## ADDENDUM NO. 1

Project Name: **San Gabriel East EST**

## SAN GABRIEL EAST ELEVATED STORAGE TANK

### PROJECT NO. 21-CIP-005

SITE PLAN & DEMOLITION PLAN

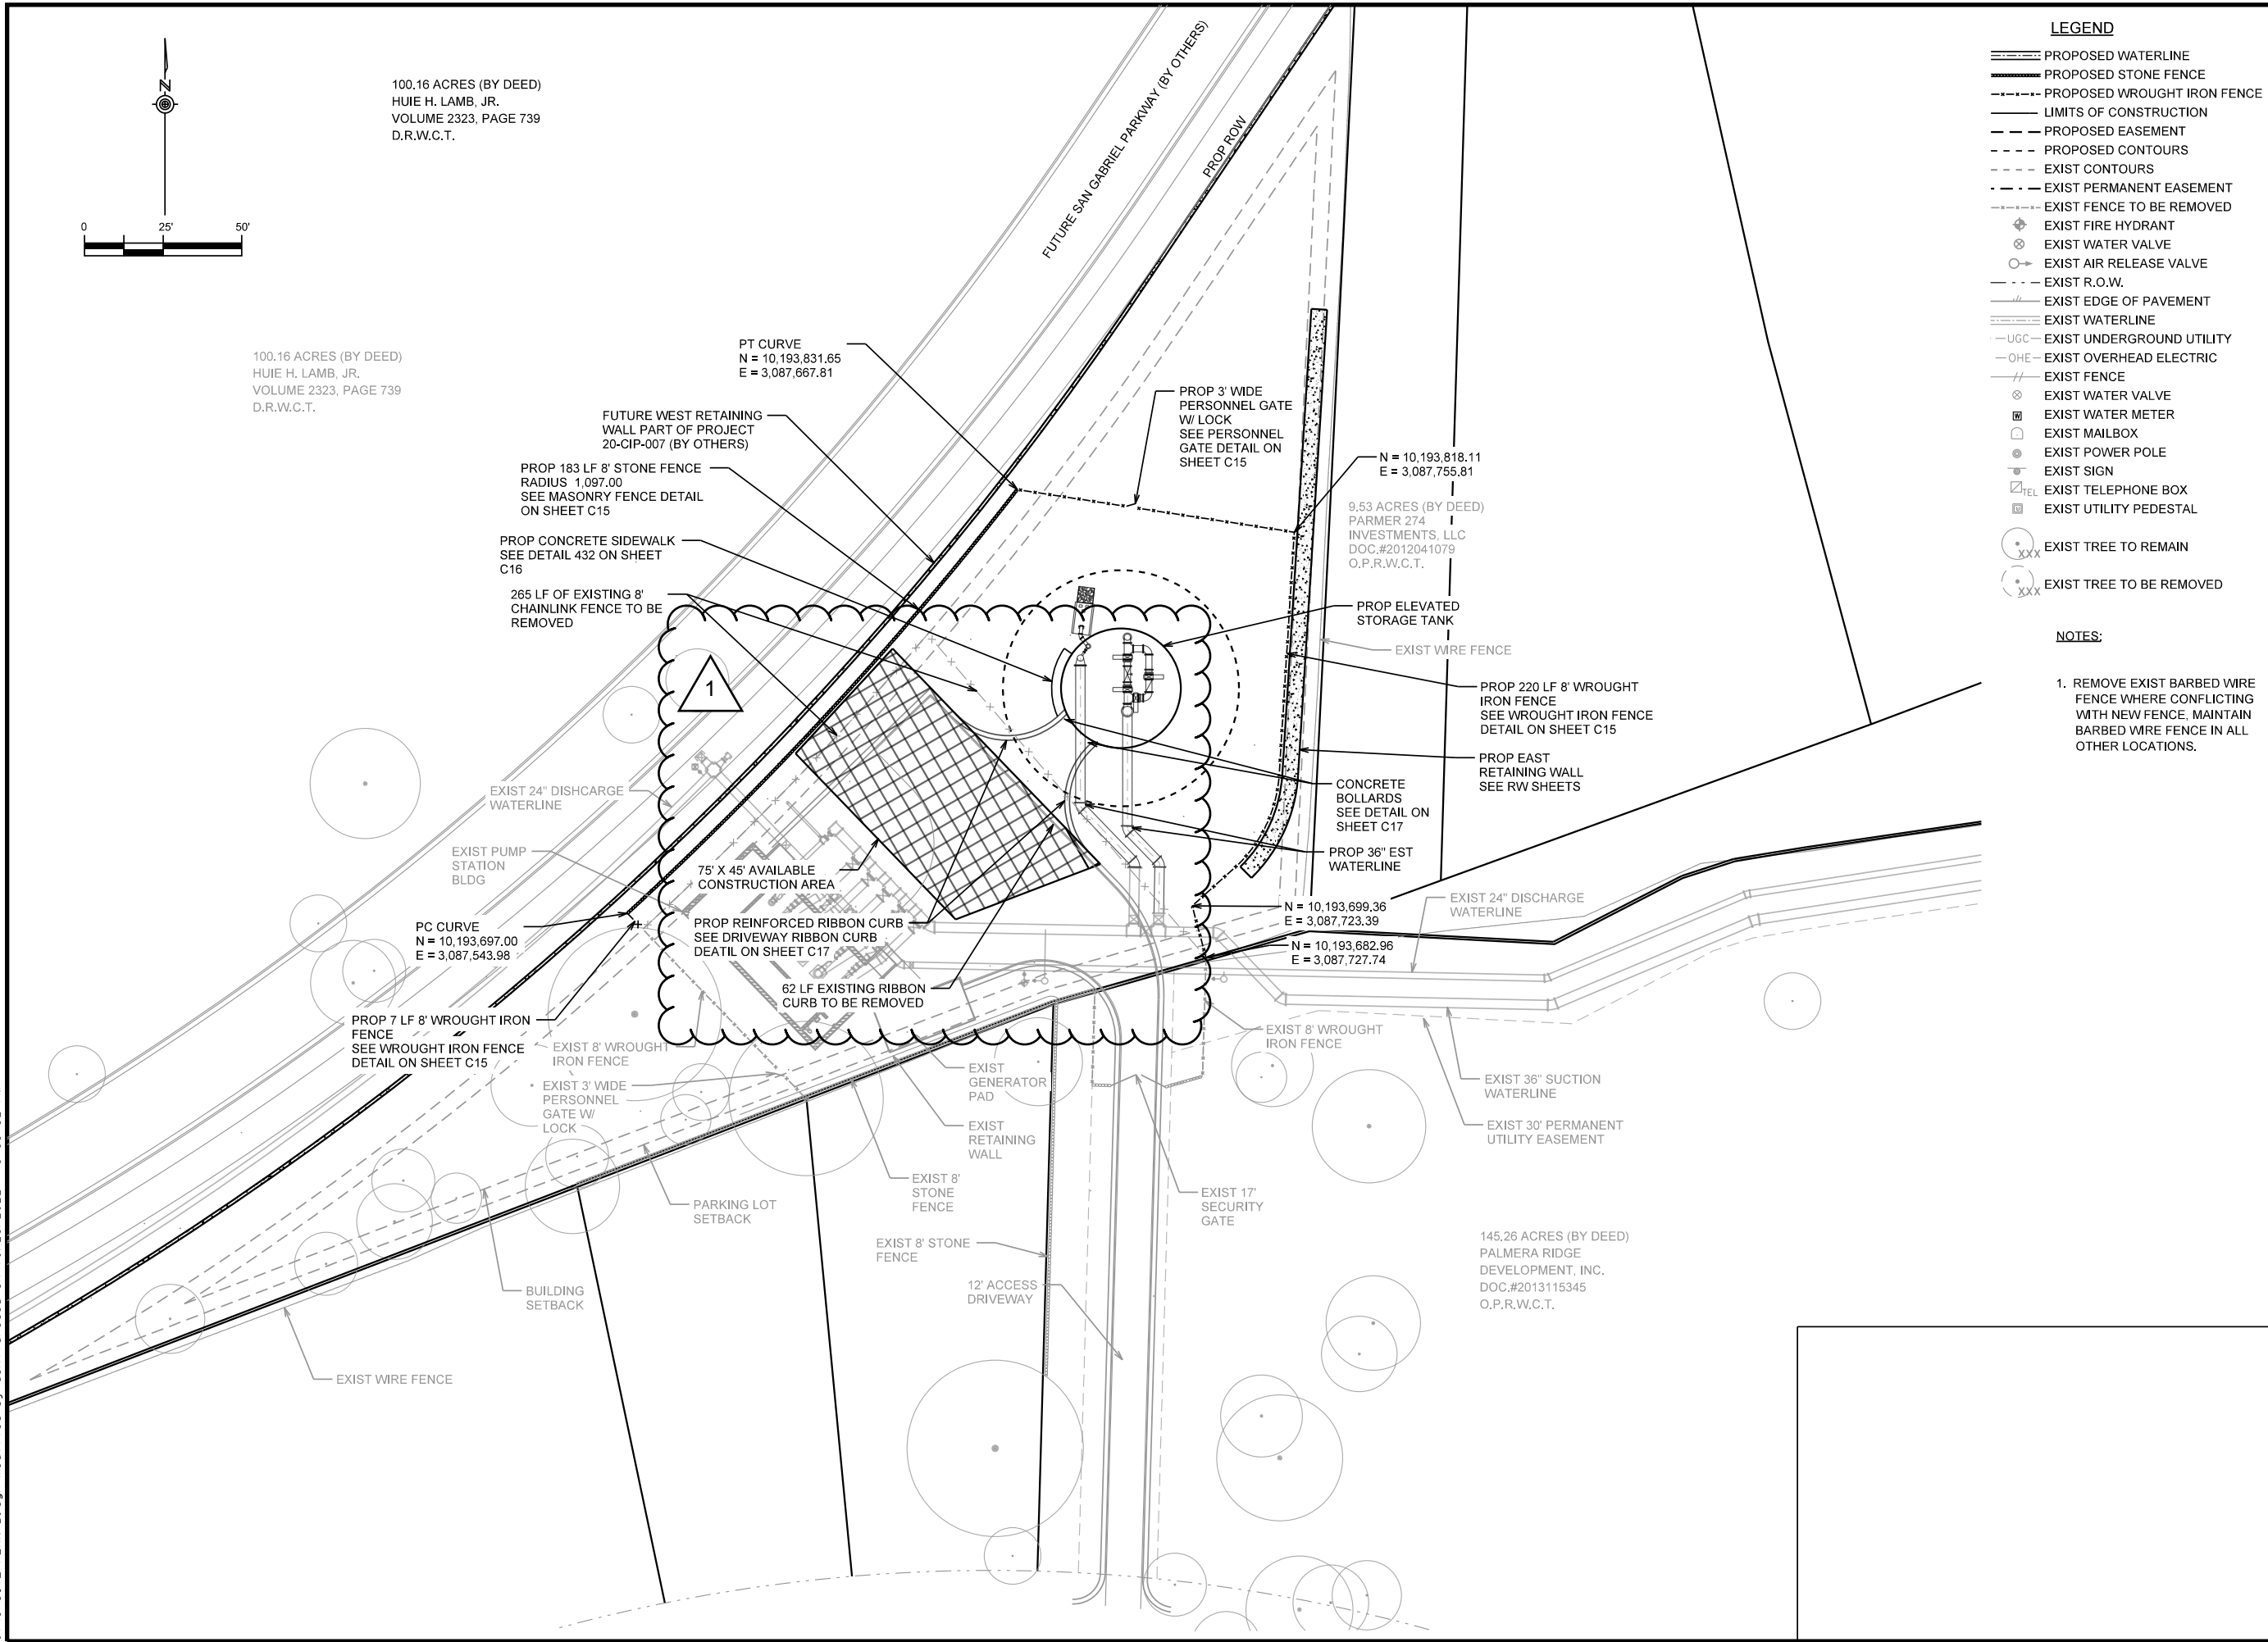
REVISION DESCRIPTION	
1	ADD CONSTRUCTION AREA
DATE	11/04/22
BY	DM
REV. NO.	1

K FRIESE & ASSOCIATES, INC.		1120 S. CAPITAL OF TEXAS HWY, II-100, AUSTIN, TX 78746	
CITY OF LEANDER		SAN GABRIEL EAST ELEVATED STORAGE TANK	
GRADING & EROSION CONTROL PLAN

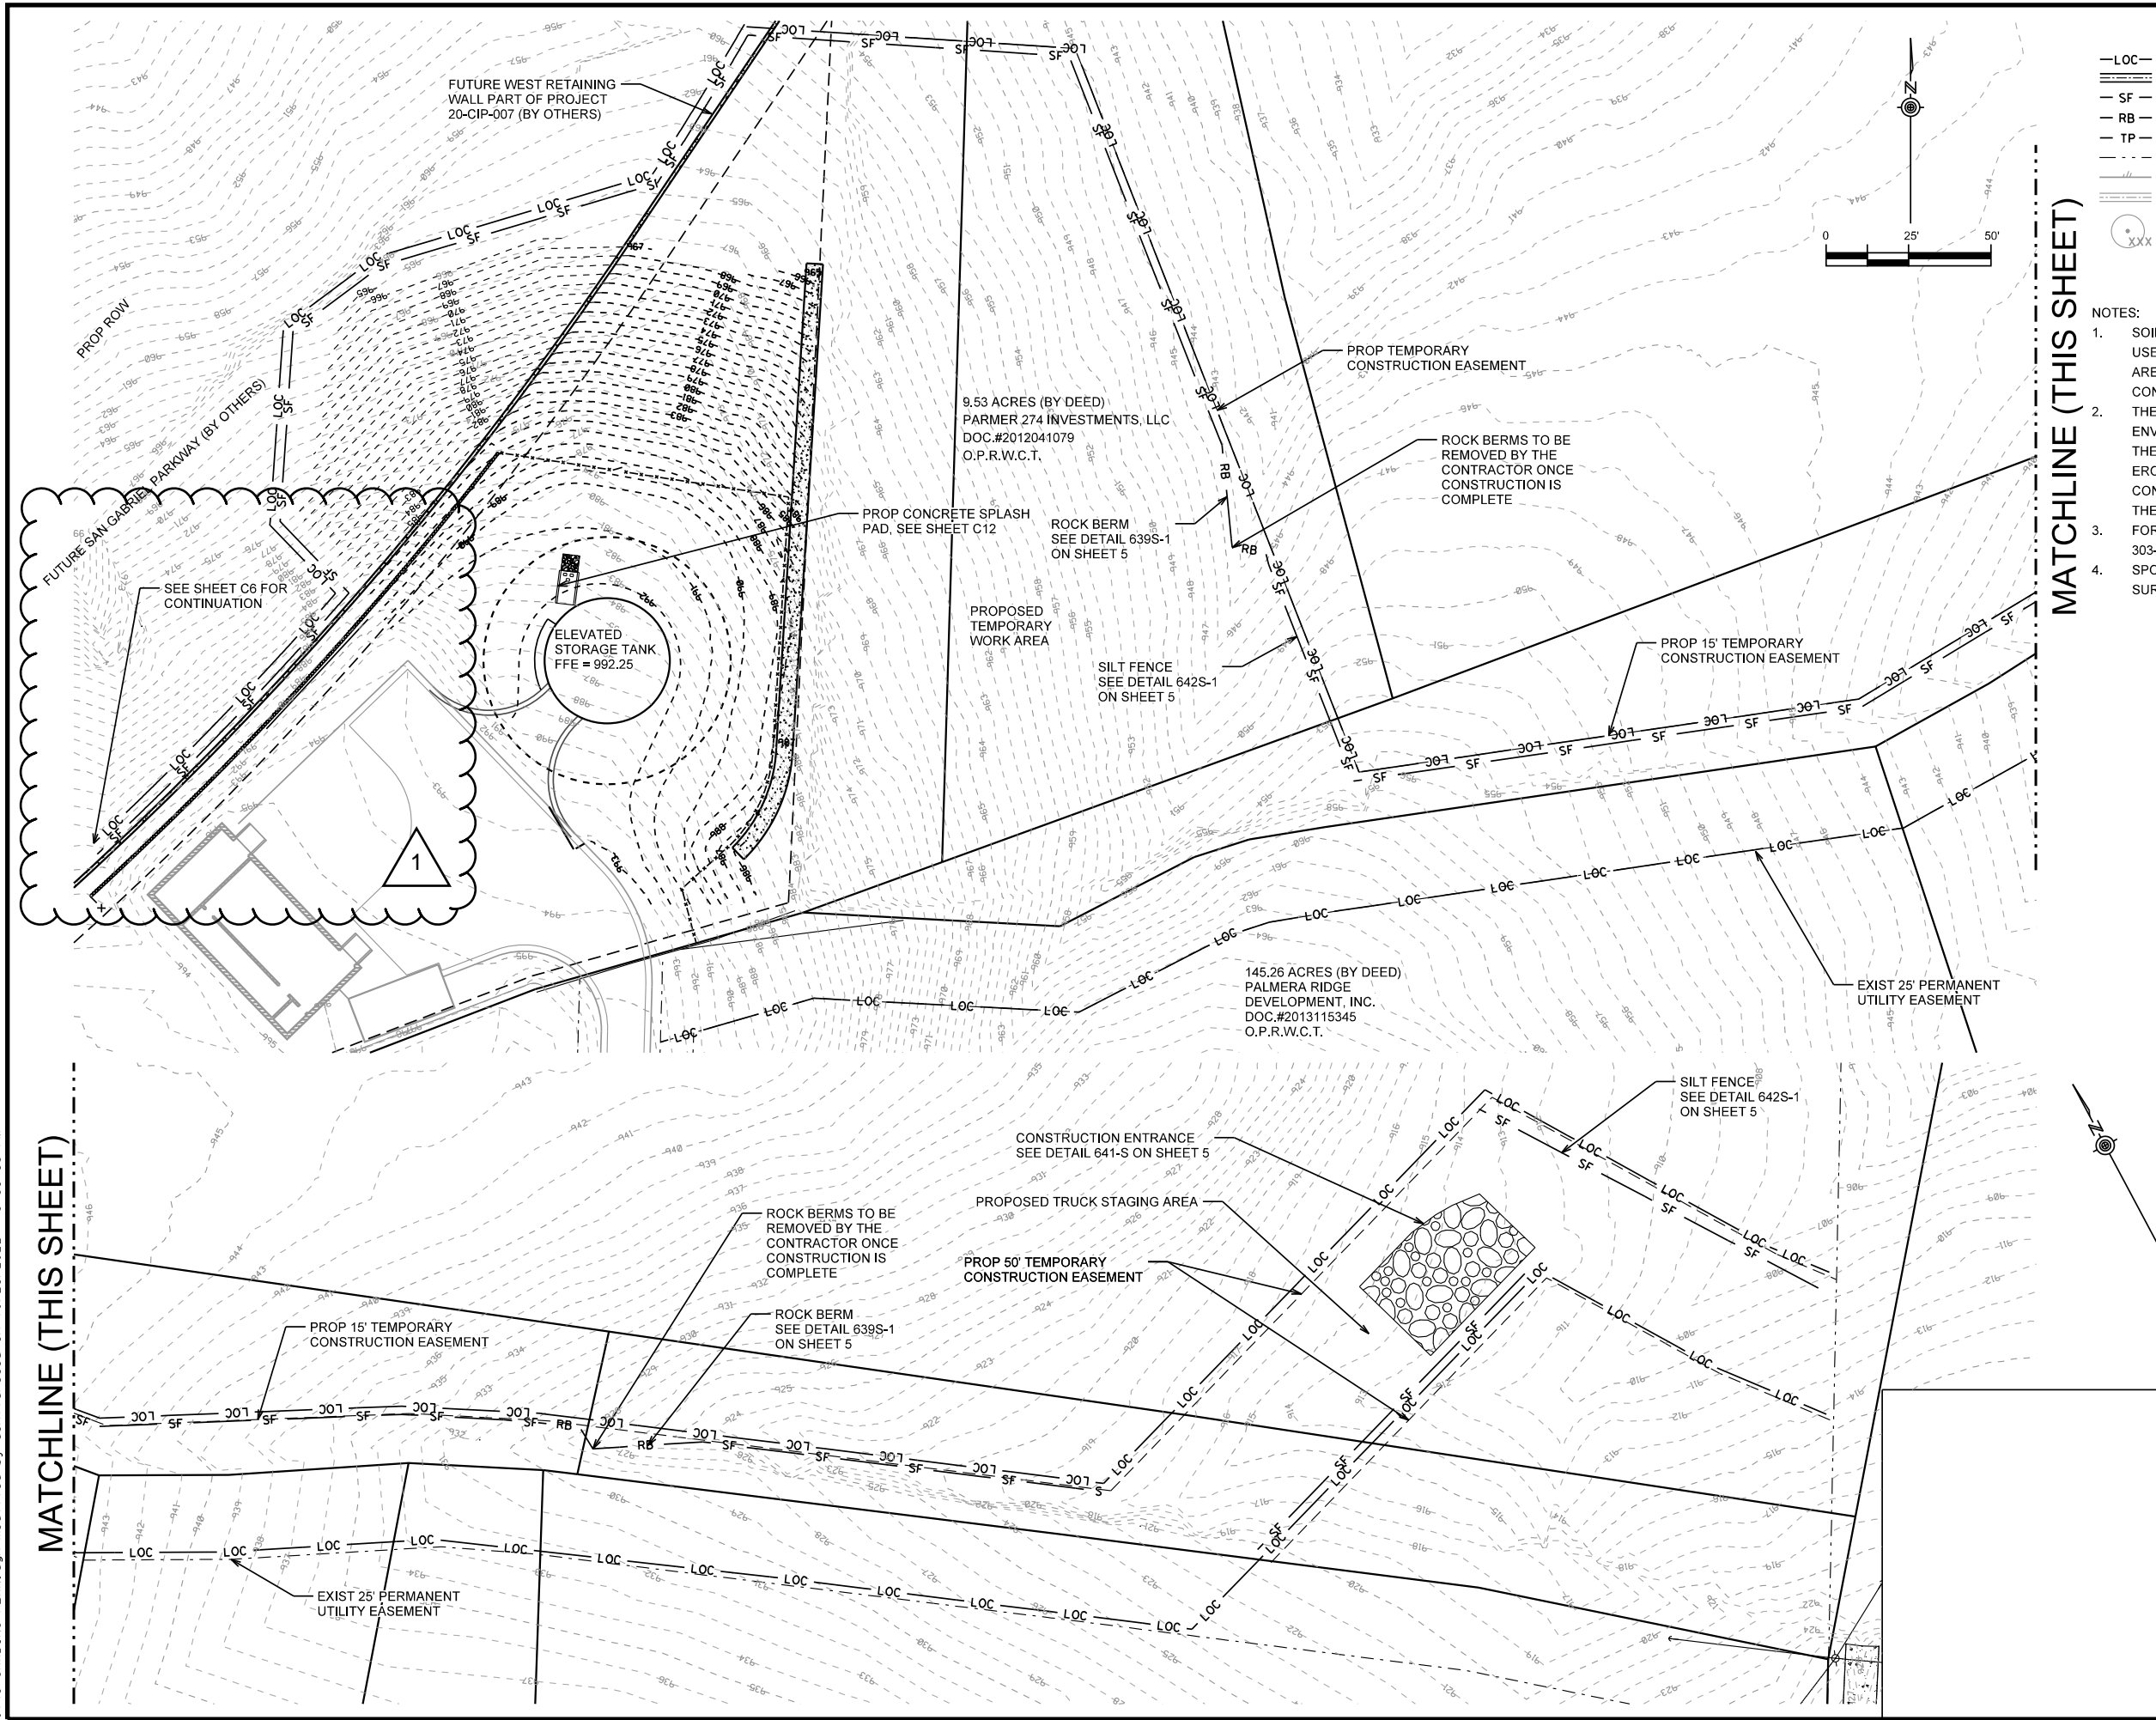
REVISION DESCRIPTION		DATE		BY		NO.	
ADD ACCESS ROAD ESC		11/04/22		DM		1
